SUBJECT: TRAFFIC METHODOLOGY APPROVAL LETTER
PROJECT NAME: ENCLAVE HOUSING CR 42 TRAFFIC IMPACT STUDY
PROJECT #2025010062 APPLICATION: #32409 PARCEL #47667-004-00

Project: Enclave Housing CR 42

Subject: Proposed Methodology for Enclave Housing CR 42

RE: Enclave Housing CR 42 Response to Comments

Figure 2. Project Trip Distribution

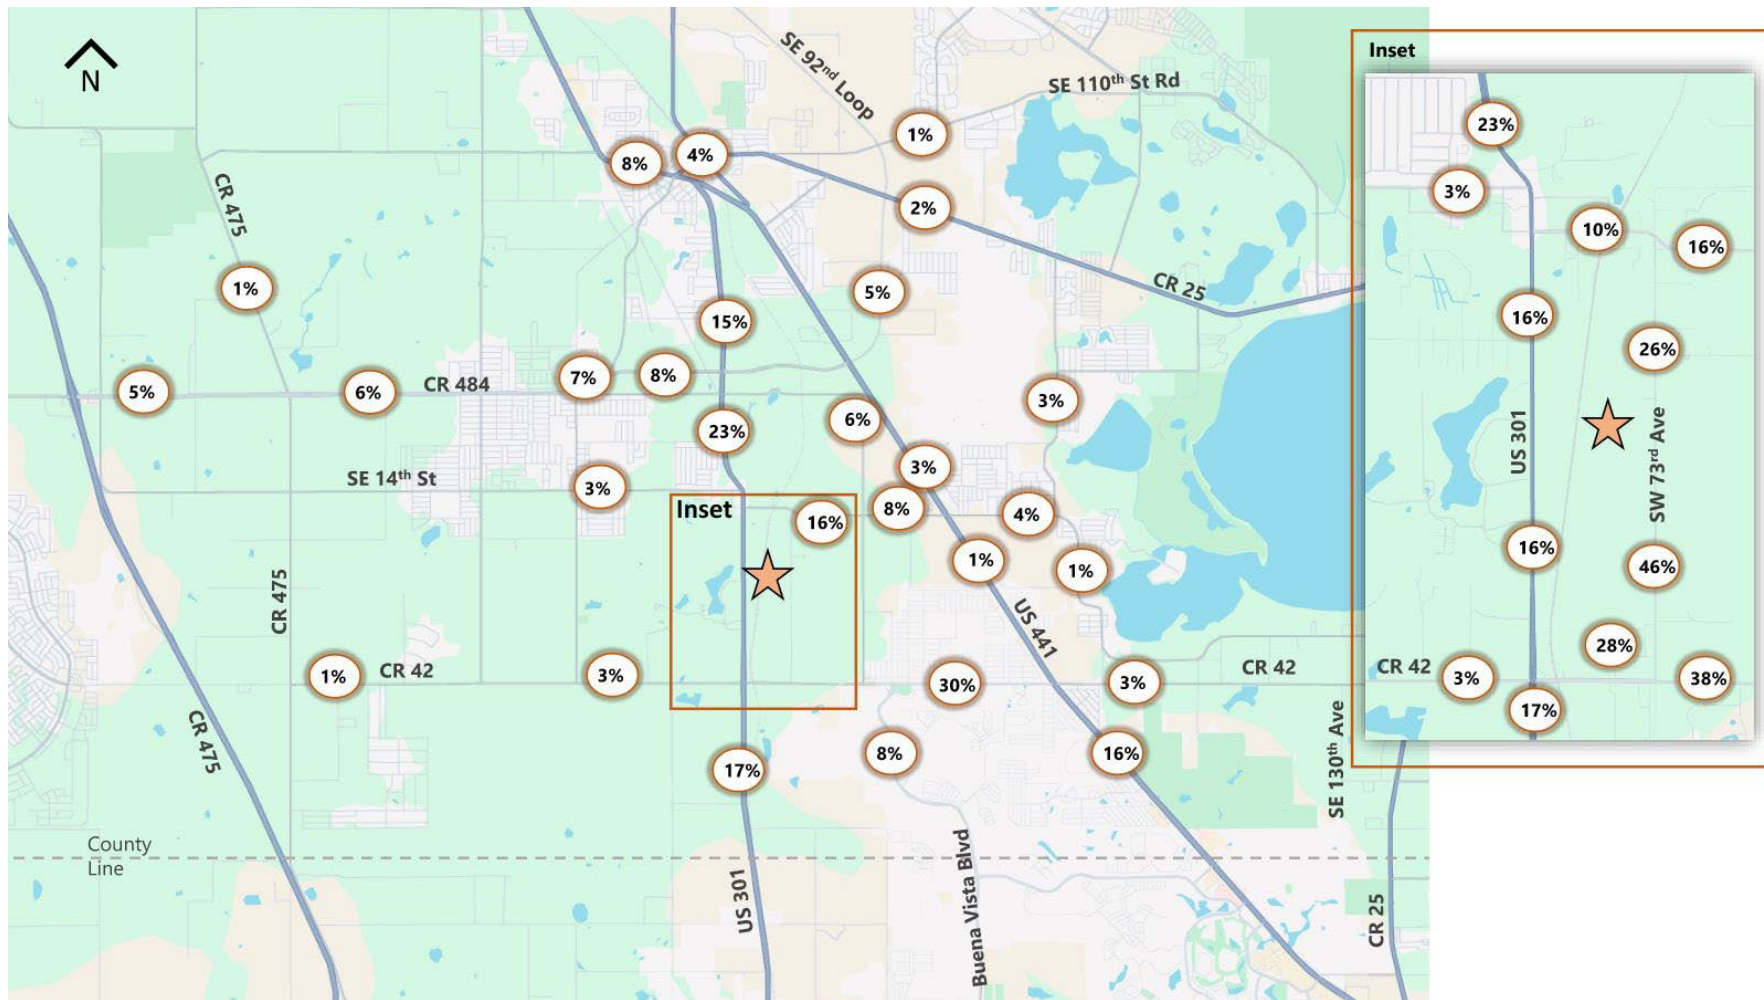
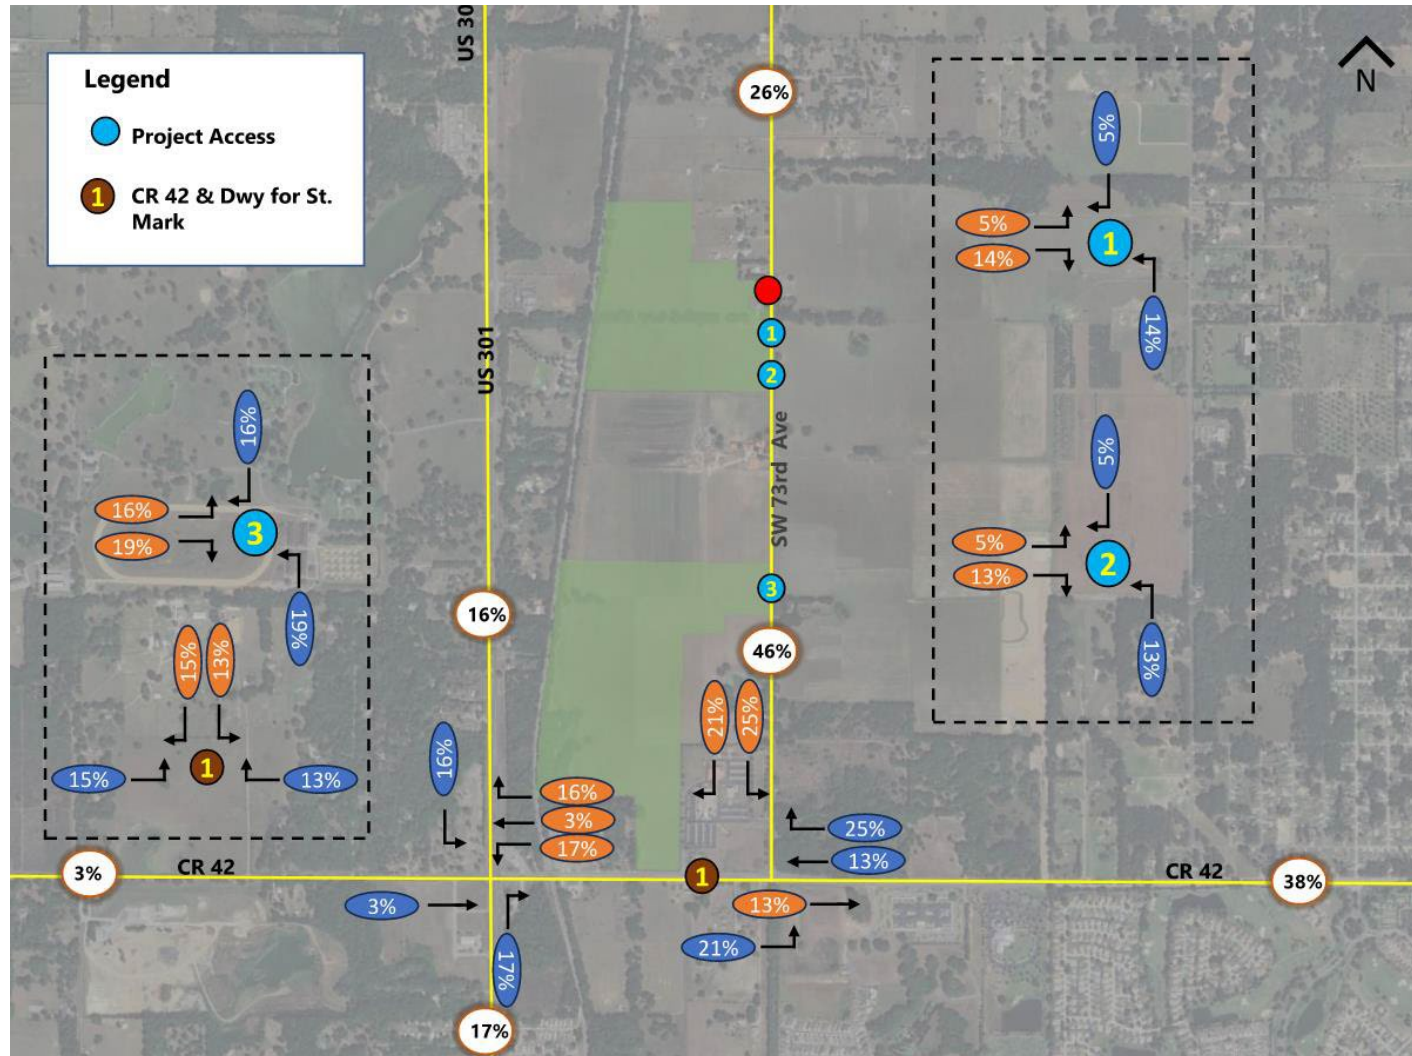
2. PDF pg. 4 & 5, Figures 2 & 3 - Figures 2 & 3 show different distributions to/from the south on SE 73rd Ave. Figure 2 shows 54% while Figure 3 shows 39%. Update the figures to show the same distributions on SE 73rd Ave. Ensure the distributions used in Table 2 also match the distributions shown on Figures 2 & 3.

Response: Agreed, and Figures 2 & 3 are updated accordingly.

Figure 3. Project Trip Distribution at Project Driveways

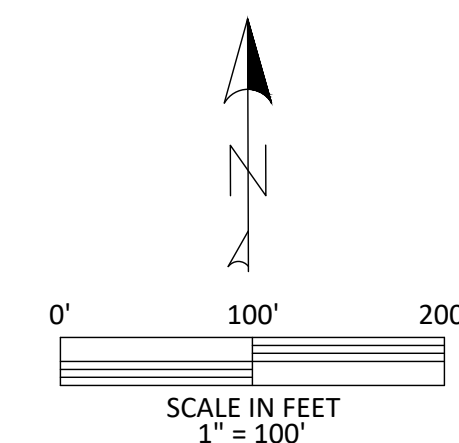
4. PDF pg. 5, Figure 3 - The 39% to/from the south on SE 73rd Ave needs to be changed to 46% based on the distributions shown at the driveways on SE 73rd Ave

5. PDF pg. 5, Figure 3 - The 15% of eastbound through traffic on CR 42 at SE 73rd Ave needs to be changed to 13%.

Response: Figure 3 has been updated to show 46% to/from the south on SE 73rd Ave.

Response: Figure 3 has been updated to show 13% eastbound through traffic on CR 42 at SE 73rd Avenue.
